May 18, 2021

SUBJECT: Conditional Approval of Groundwater Extraction and Treatment System (GETS)
Interim Remedial Action Design Report (RADR)
JCI/Tyco FTC PFAS, 2700 Industrial Parkway South, Marinette, WI
BRRTS #02-38-580694

FIGURE
5-1

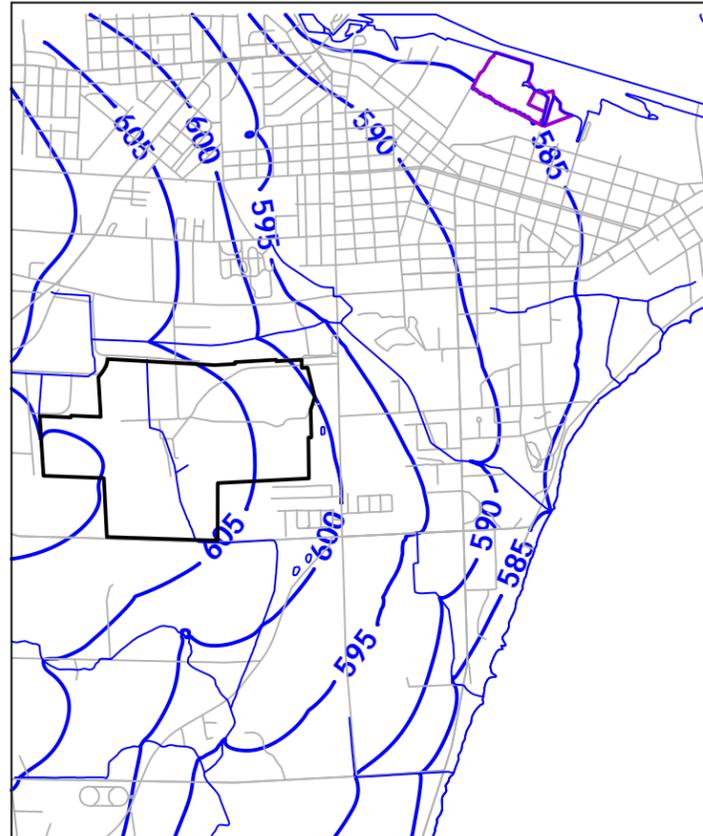
- *Update the Monitoring Network, Sampling Frequency and Reporting Schedule:*
Incorporate the revisions to the monitoring network, sampling frequency and reporting schedule that are specified in Attachment B. **Following completion of the startup phase, the DNR approves JCI/Tyco's request to submit the Wis. Adm. Code § NR 724.17 long-term monitoring data with the Wis. Adm. Code § NR 724.13(3) semi-annual progress reports.** This approved reporting schedule is included in **Attachments B and C.**

- Construct a new well near piezometer PZ-22S/-22D to a depth of approximately 52 ft bgs with a 5-foot well screen; include as part of sampling plans for water level gauging and baseline and semi-annual PFAS sampling.
- Add existing monitoring wells PZ-1S and PZ-15S into the baseline and quarterly PFAS sampling. Include both wells in the water-level gauging.
- Collect groundwater samples for PFAS from the five temporary piezometers proposed for Ditch B (TPZ-U03, TPZ-M09, TPZ-M07, TPX-M04, and TPZ-M01). Collect the samples concurrent with the surface water samples and the water-level measurements at these locations.

FIGURE
B-8

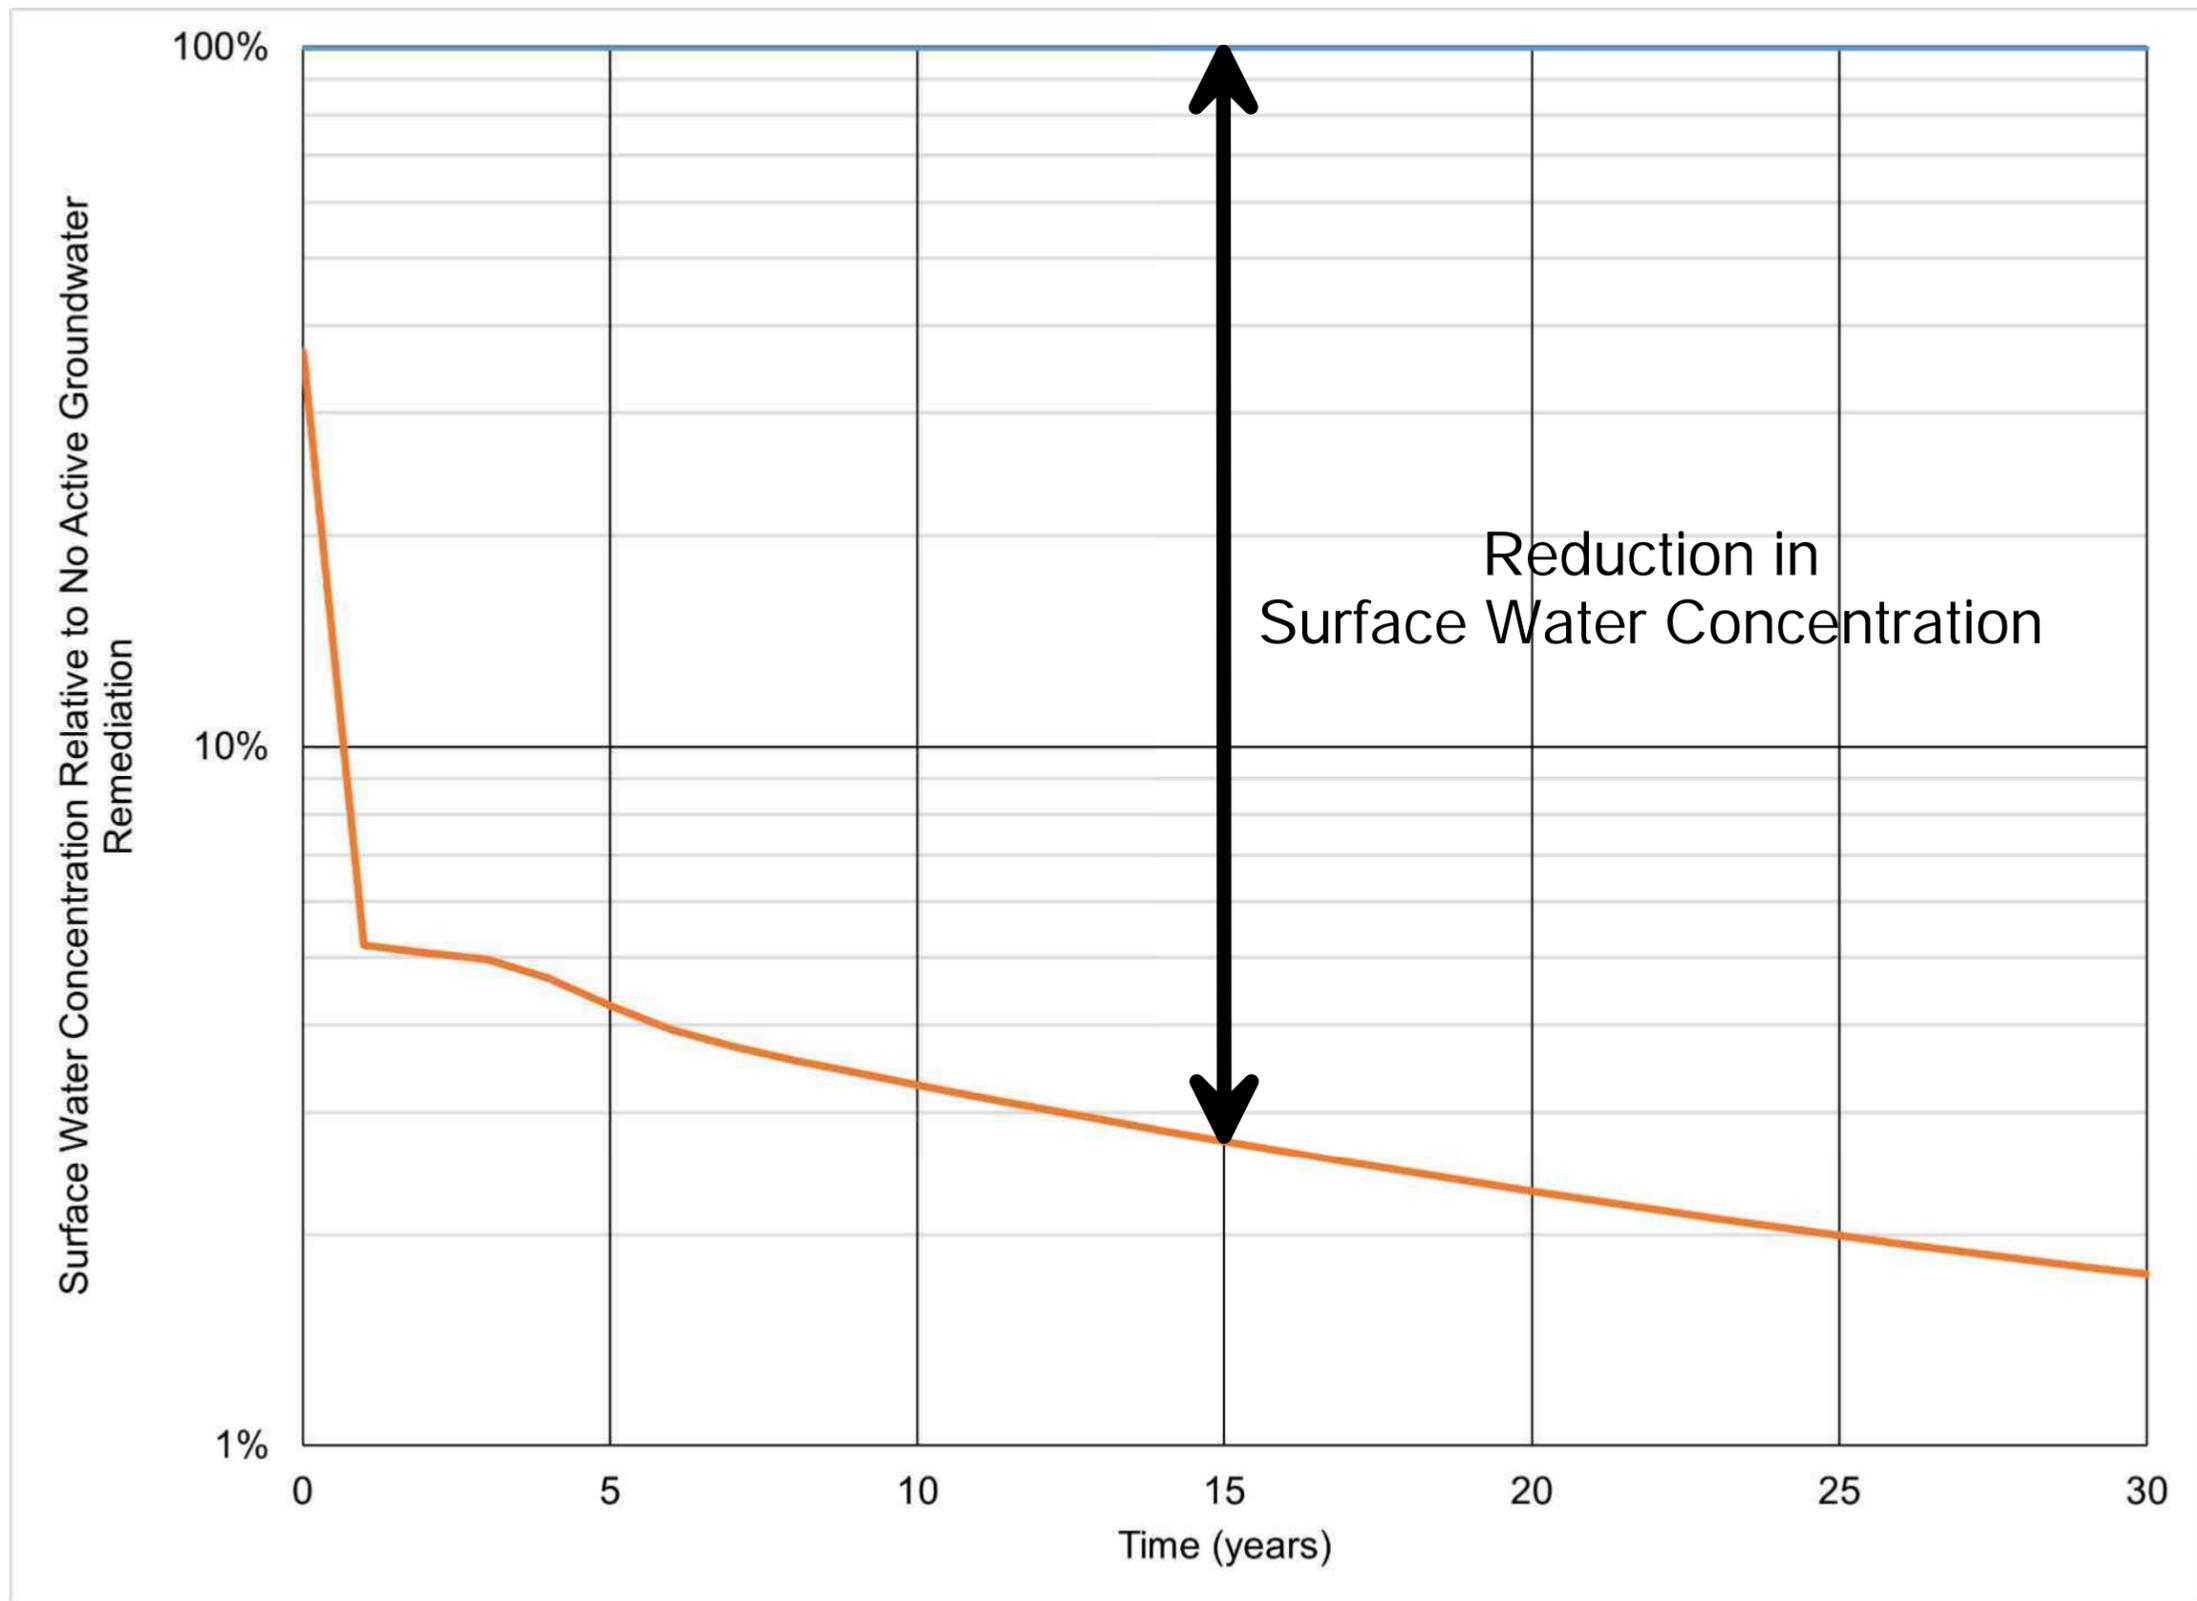
Using the current available data, JCI/Tyco concluded that groundwater with PFAS concentrations greater than 10,000 part per trillion (ppt) is present beneath and to the east of the FTC property (see Figure B-8 from the GETS RADR provided in **Attachment A**). Some of the contaminated groundwater upwells and contributes to the PFAS contamination detected in surface water in Ditch B, which then flows into the Bay of Green Bay in Lake Michigan. Based on these findings JCI/Tyco proposed an interim remedial action to pump and treat areas of highly contaminated groundwater that are migrating east from the FTC towards Ditch B.
